SURVEY SUMMARY – STATE COLLEGE, PA

Attention: State College, PA Project Name: State College Skatepark at High Point Park

The following is a summary of the feedback gathered from the online survey and the design workshop webinar on Thursday, January 27th. The workshop was held virtually using Zoom Webinar to gain input regarding potential skatepark terrain and comments on the sample designs provided. Please review and contact NLS with any questions or comments.

Part Two: Current Concept Feedback:

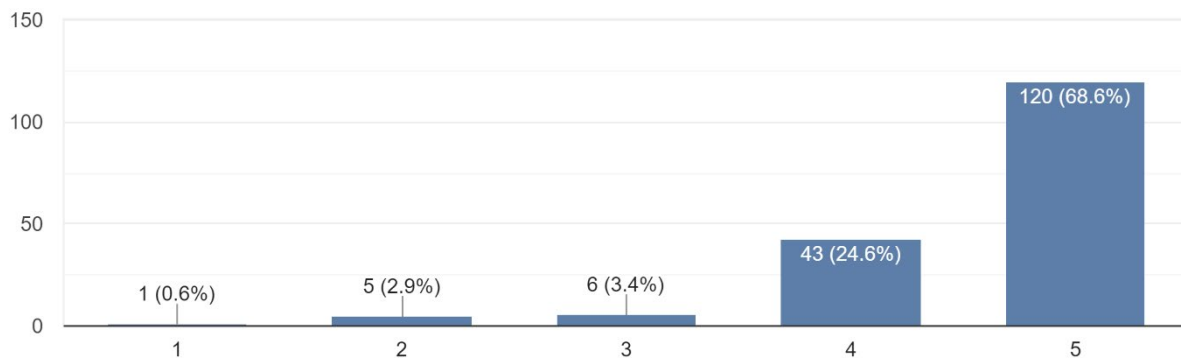
- **Variety** of features.
- The floating mini-ramp & plaza section.
- Great flow around park.
- Size of features aren't too big.
- **Granite material & plaza style.**
- Attention to **local architecture.**
- **Green space** within design.
- Balance between spacious and obstacles.
- Lots of ledges.
- Transition area looks friendly and good for beginners.

- Make sure features are sized correctly.
- Make sure spacing is adequate and not **too cramped.**
- Would like a “micro mini ramp” included.
- **More furnishing and seating around exterior, support areas for resting.**
- Wish there could be lights.
- The transition area could be a **closed off bowl** instead of open.

- Large variety of features for progression.
- Area to flow around and do long lines.
- Contains street terrain that isn't available in the region.
- Focus on beginners and community make the park feel inviting.
- Aesthetics and overall “vibe” is a welcome addition to a skatepark.
- Transition area needs slight adjustment, but overall great design.
- Low risk of collisions.
- It will be exciting to have a skatepark in the community.

Survey Participants showed immense support for the current concept. The most common comment was to refine the transition area to help contain flow or give a bit more space to individuals who only want to skate transition.
